MILITARY SPECIFICATION

SWITCHES, TOGGLE, ENVIRONMENTALLY SEALED;

GENERAL SPECIFICATION FOR

This amendment forms a part of Military Specification MIL-S-3950F, dated 14 February 1976, and is approved for use by all Departments and Agencies of the Department of Defense.

"40.4 Terminal screw with captive split ring lockwasher.

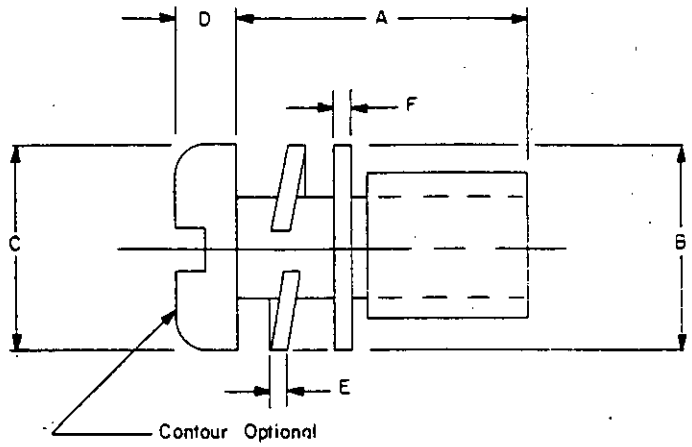
* Following 40.3, add:

INCHES	MM
.010	.25
.020	.51
.031	.79
.037	.94
.071	1.80
.087	2.21
.138	3.51
.248	6.30
.256	6.50
.265	6.73
.280	7.11
.290	7.37

Thread size	A	B	C	D	E	F
.138-32 UNC-2A	.280 .248	.265 Max	.290 .256	.087 .071	.037 .031	.020 .010

Screw (steel)	Material	FED-STD-66
	Finish	Solder plate or cadmium plate per QQ-P-416, type II, class 3
Helical lockwasher (steel)	Material	FED-STD-66
	Finish	Solder plate or cadmium plate per QQ-P-416, type II, class 3
Flat washer (steel)	Material	FED-STD-66
	Finish	Solder plate or cadmium plate per QQ-P-416, type II, class 3
Military hardware		Can be replaced with MS35206-226 screws and MS35338-41 lockwashers.
